### 9.6.2 Disable statement

### 16.4 Deferred Assertions

### 36.47 Sequence expression

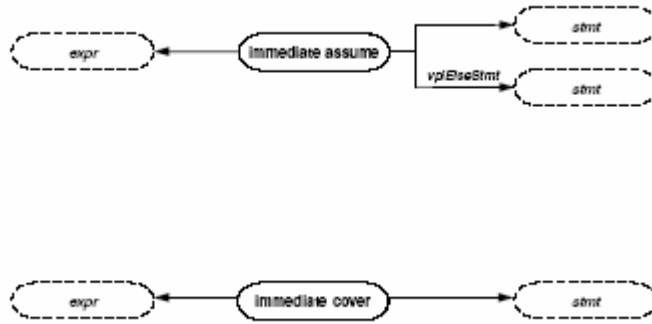
REPLACE

**WITH**

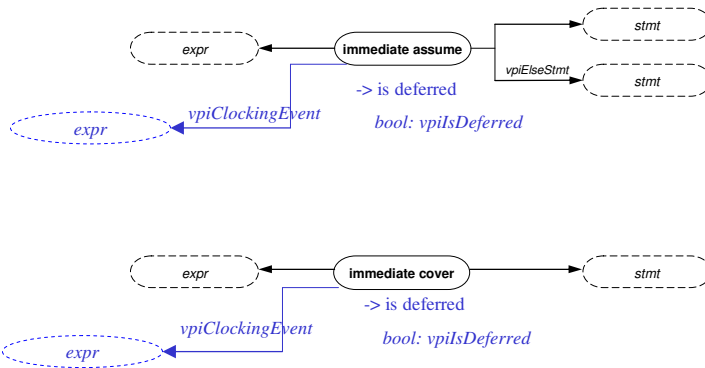
If proposal 1729 has been accepted, REPLACE

WITH
